## CITY of NOVI CITY COUNCIL

**Agenda Item 1**  
**August 27, 2018**

**SUBJECT:** Consideration for approval of the request of Pulte Homes of Michigan, LLC, JSP17-62, for a Planned Suburban Low-Rise (PSLR) Overlay Development Agreement Application and Revised Concept Plan for the Villas at Stonebrook development. The subject property is approximately 26 acres of land located on the east side of Wixom Road, north of Eleven Mile Road, in Section 17. The applicant is proposing 43 duplex units (86 homes total) in "age-targeted" ranch-style homes.

CLIENT  
PULTE HOMES  
THE VILLAS AT STONEBROOK  
ALTERNATIVE MITIGATION PLAN  
WETLAND AND WOODLAND  
ANALYSIS

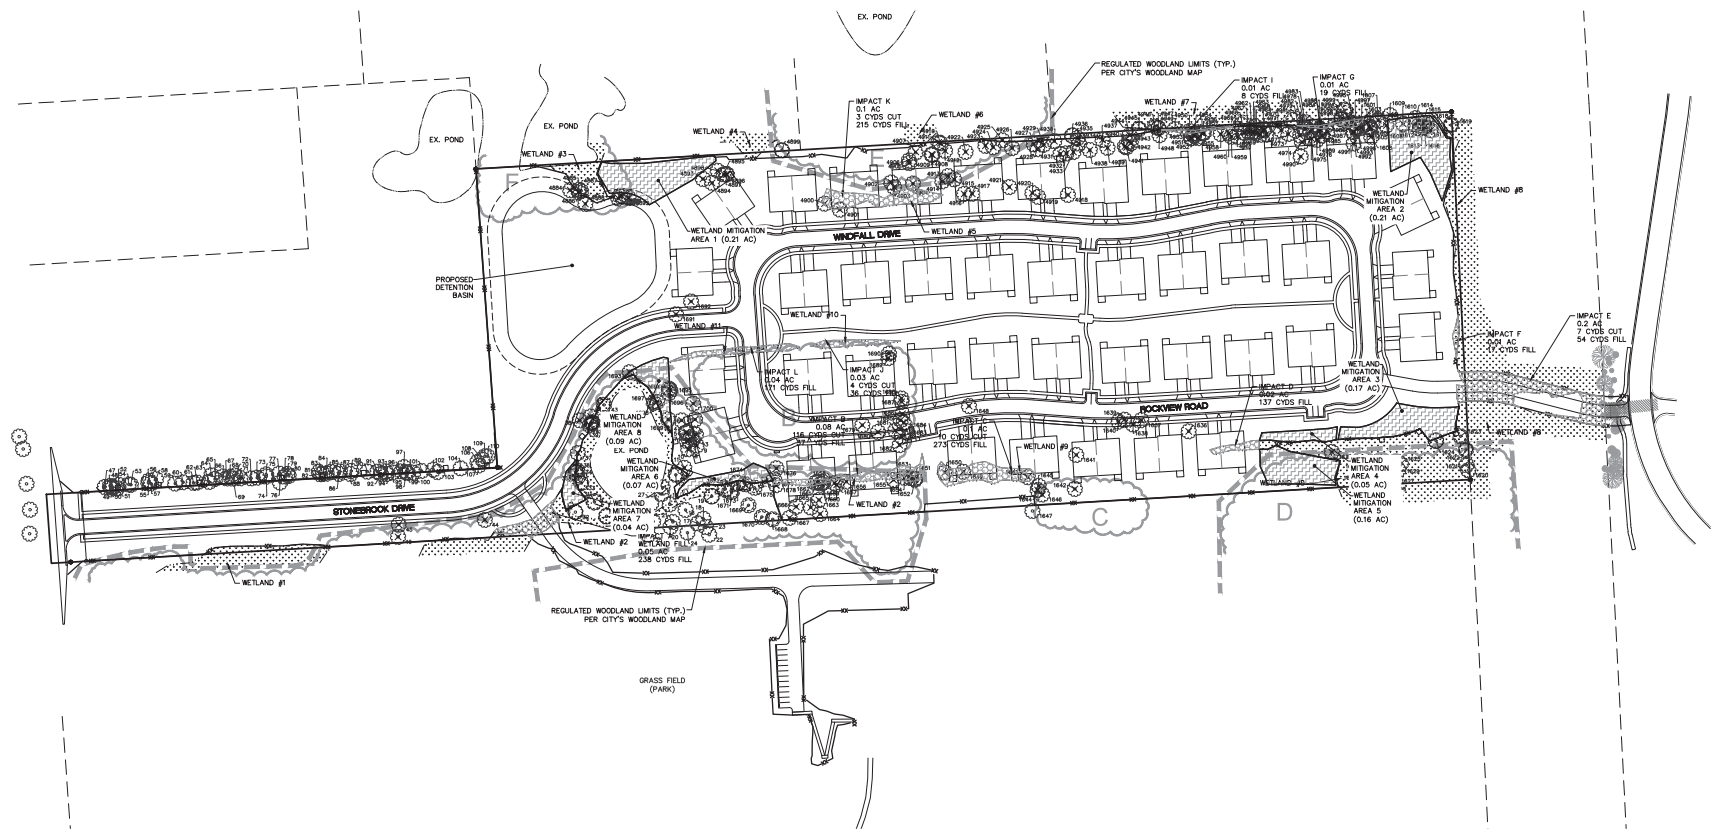
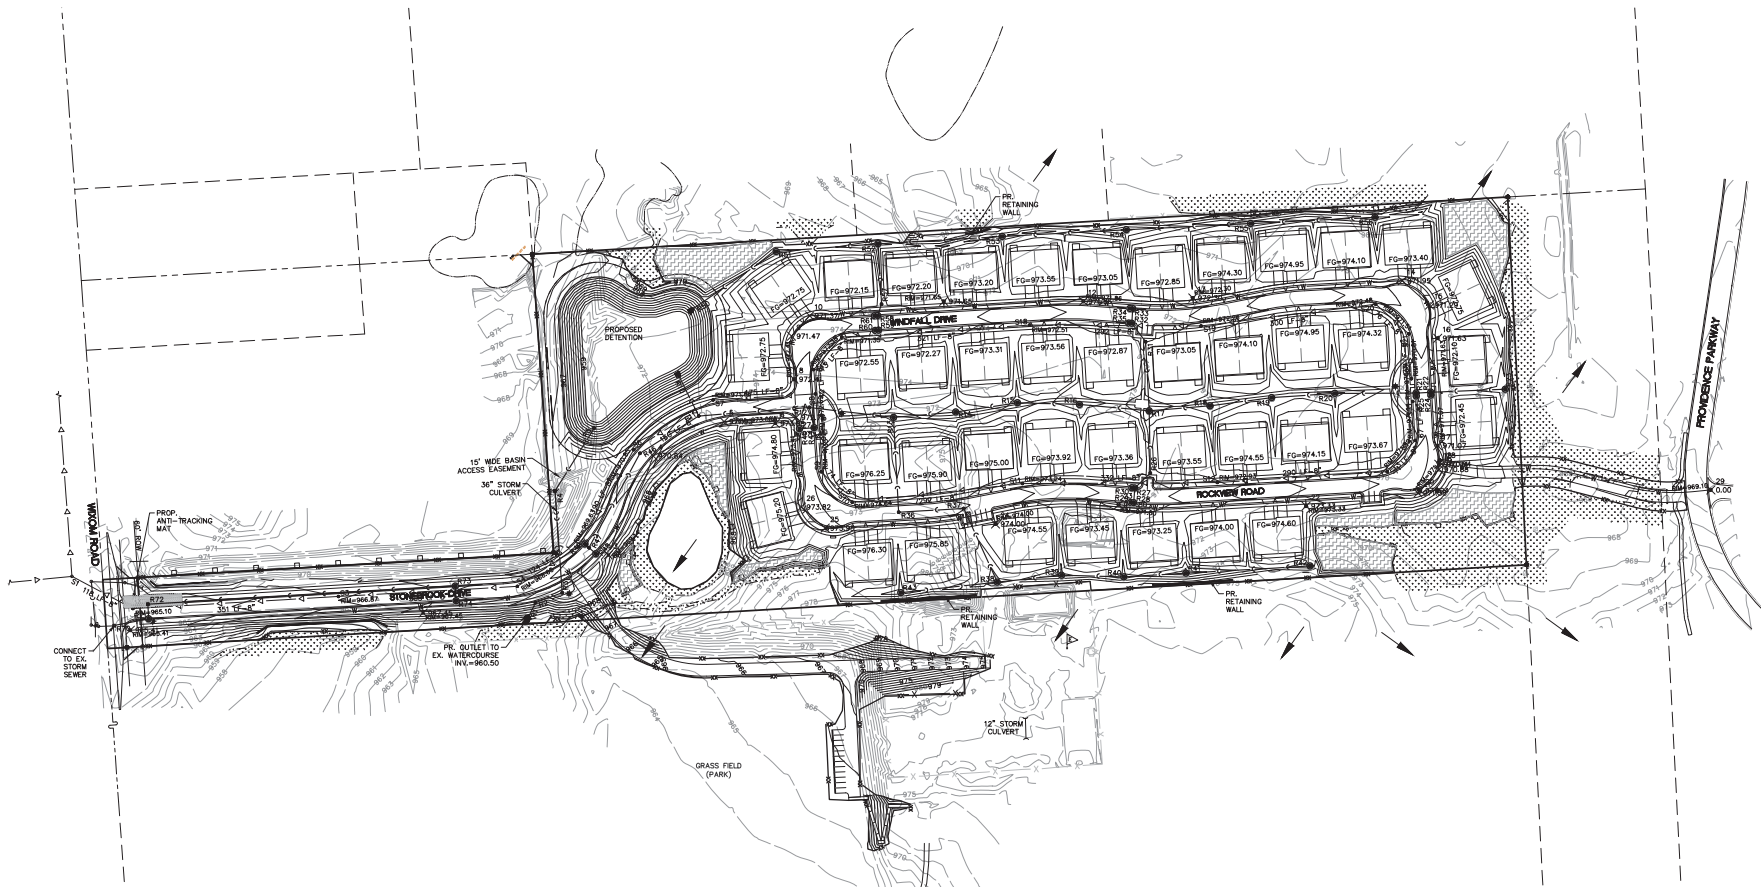
3. The applicant will need to provide wetland mitigation for impacts to the wetlands. The concept plan did not show the location for the wetland mitigation, but indicated that the wetland mitigation would be off-site. Based on comments from staff, the applicant has provided an alternative plan indicating that if such off-site mitigation cannot be located, the applicant intends to construct "Plan B" showing on-site mitigation on-site (adjacent to existing wetland areas) with the reduction of two units, if this alternate plan is implemented.
